Hocking Valley Community Hospital

Re: License #: 34-26449-01

We respectfully submit this updated room schematic to revise our current license, effective immediately. If there are any questions or further documentation is required, please contact Ward Murrey, C.N.M.T. at ext. 204.

ROOM LAYOUT
OMEGA 500 SENTINEL SPECT CAMERA
NucLear MAC COMPUTER

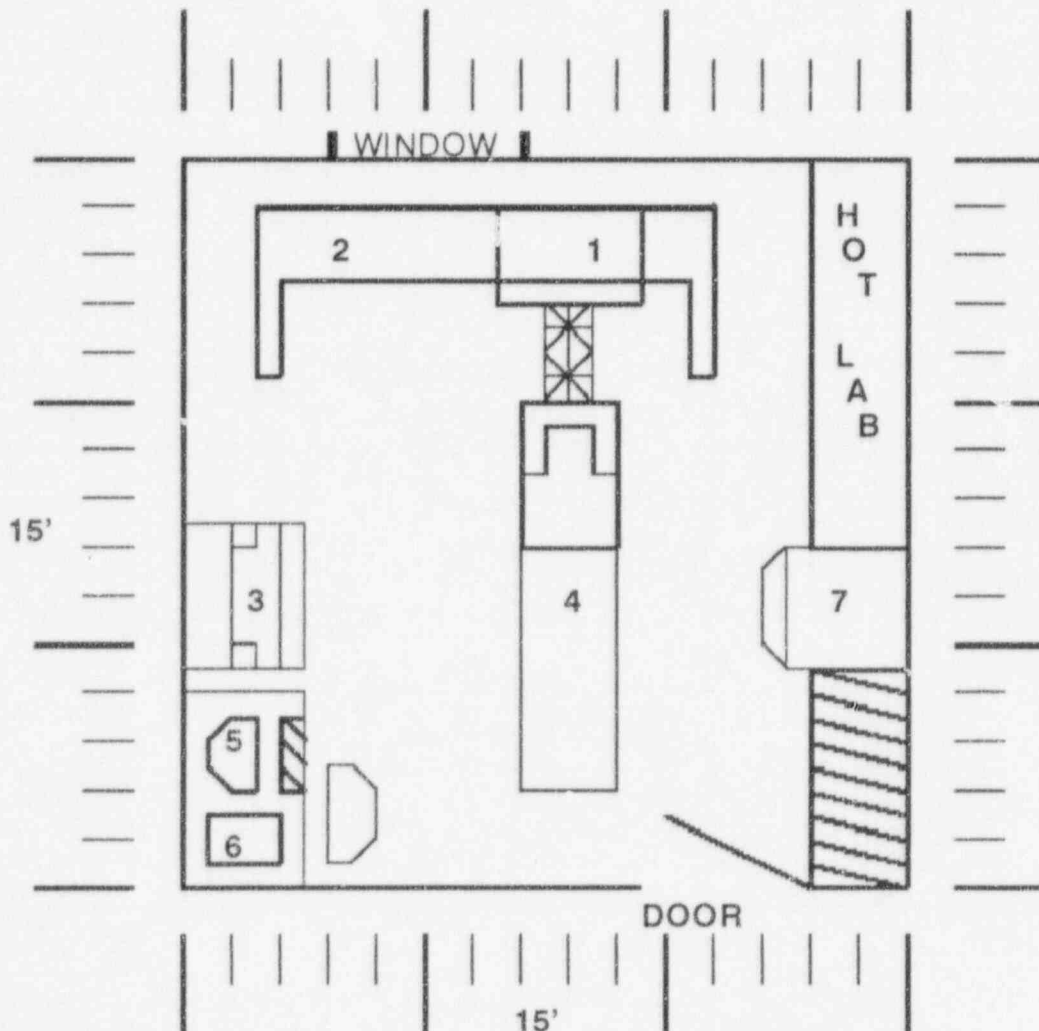
The Nuclear Medicine Lab here at Hocking Valley Community Hospital has recently undergone an equipment upgrade. These changes only effect the placement of imaging equipment and do not in any way disturb the location our of radioactive sources.
